The drawing of Lion enclosure to be constructed at the Children's Park cum Mini Zoo at Binkadakatti, Gadag, Karnataka was approved in the 86th Meeting of the Expert Group on Zoo Designing of the Central Zoo Authority held on 23.07.2019 subject to compliance of the following:-

DETAIL PLAN OF LION ENCLOSURE AT GADAG ZOO.

DETAIL SECTIONS OF LION ENCLOSURE AT GADAG ZOO.

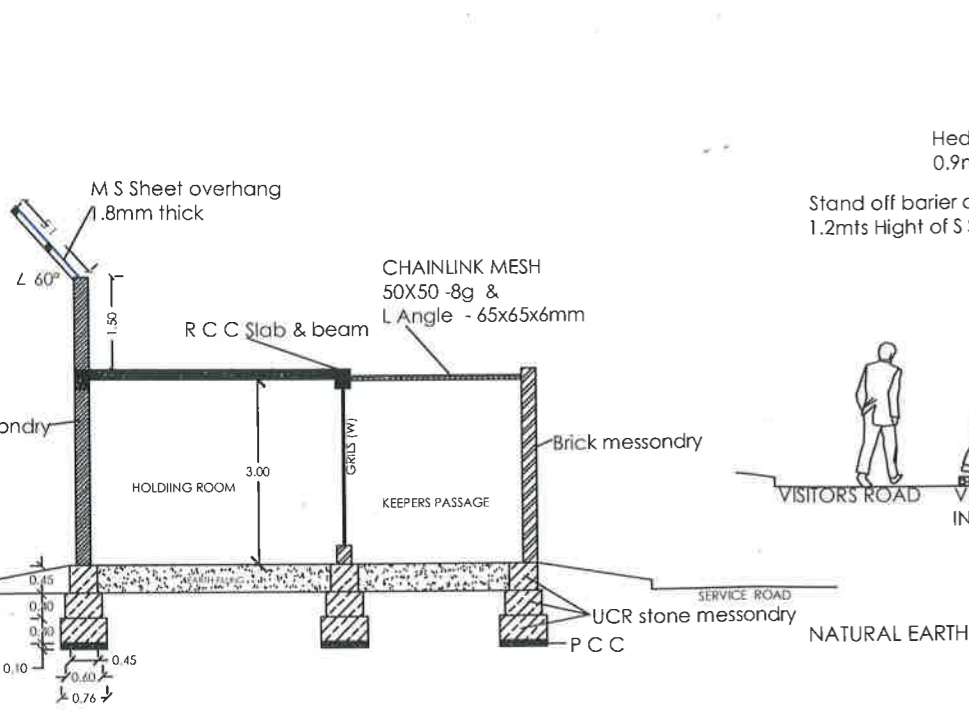
- a. In the front side of the feeding and retiring cells, towards keeper gallery, no wall is required, instead it should have MS bar only.
- b. The plantation to be done in front of the feeding cells and retiring cells to camouflage, view from visitor side.

ELEVATION OF HOLDING ROOM (feeding & retiring cells)

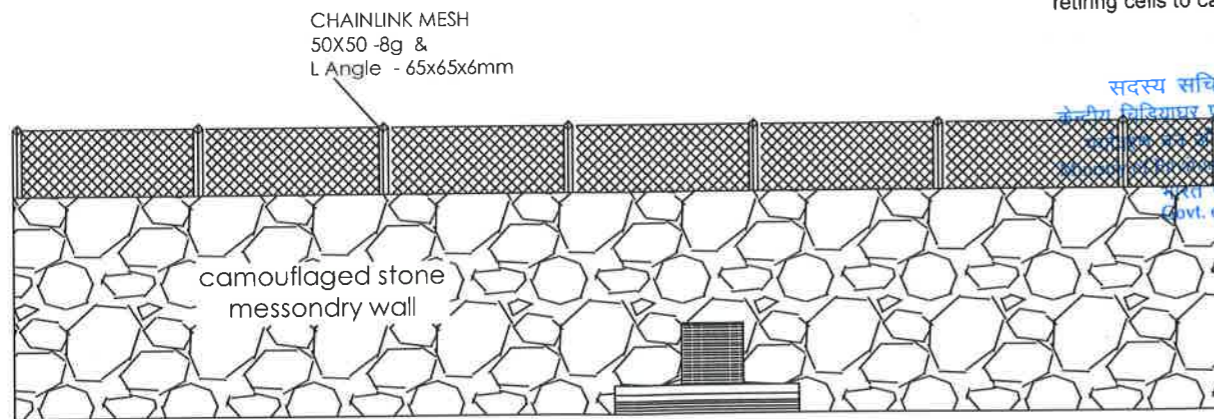
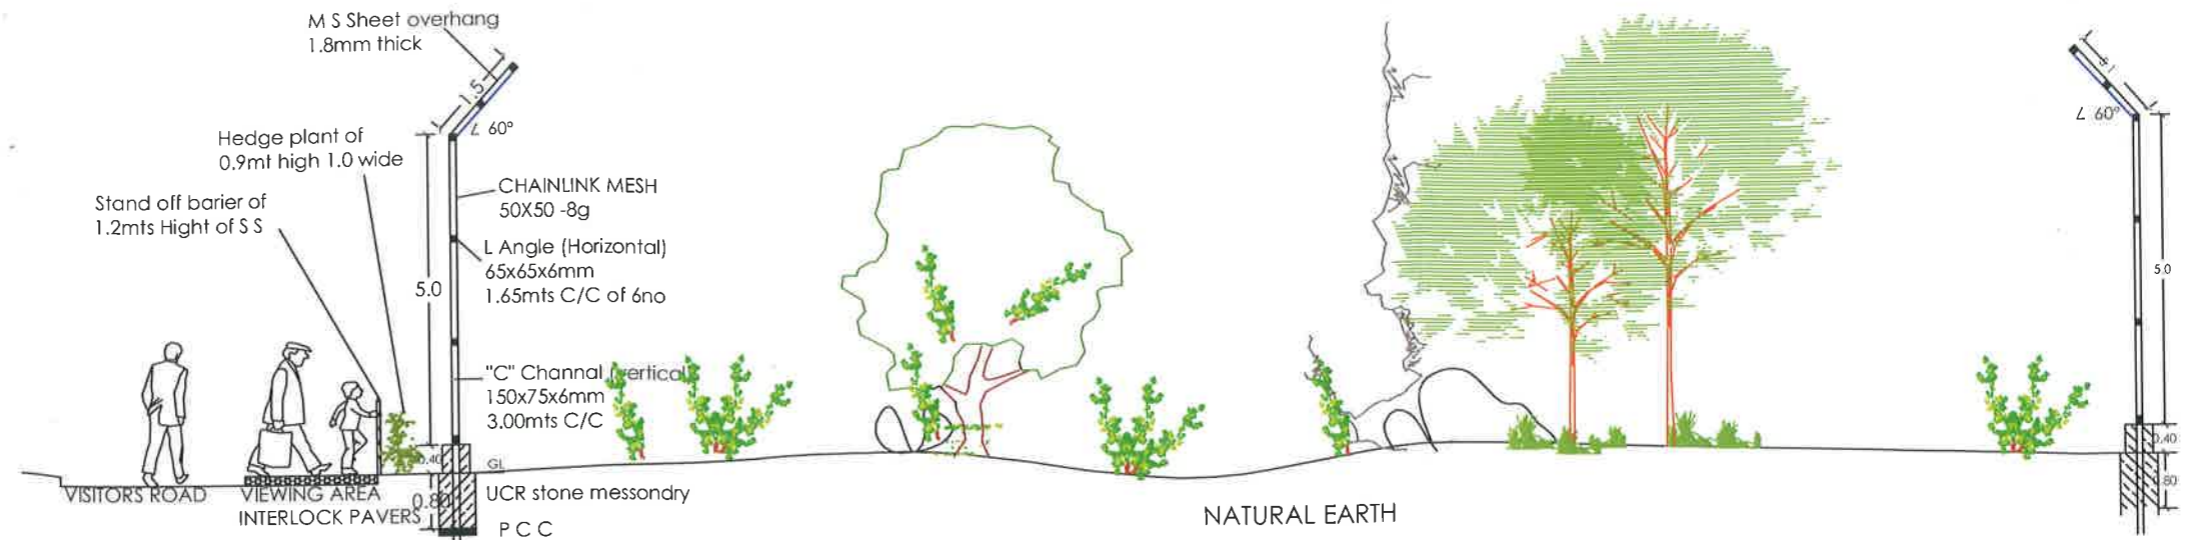
The drawing of Lion enclosure to be constructed at the Children's Park cum Mini Zoo at Binkadakatti, Gadag, Karnataka was approved in the 86th Meeting of the Expert Group on Zoo Designing of the Central Zoo Authority held on 23.07.2019 subject to compliance of the following:-

- a. In the front side of the feeding and retiring cells, towards keeper gallery, no wall is required, instead it should have MS bar only.
- b. The plantation to be done in front of the feeding cells and retiring cells to camouflage, view from visitor side.
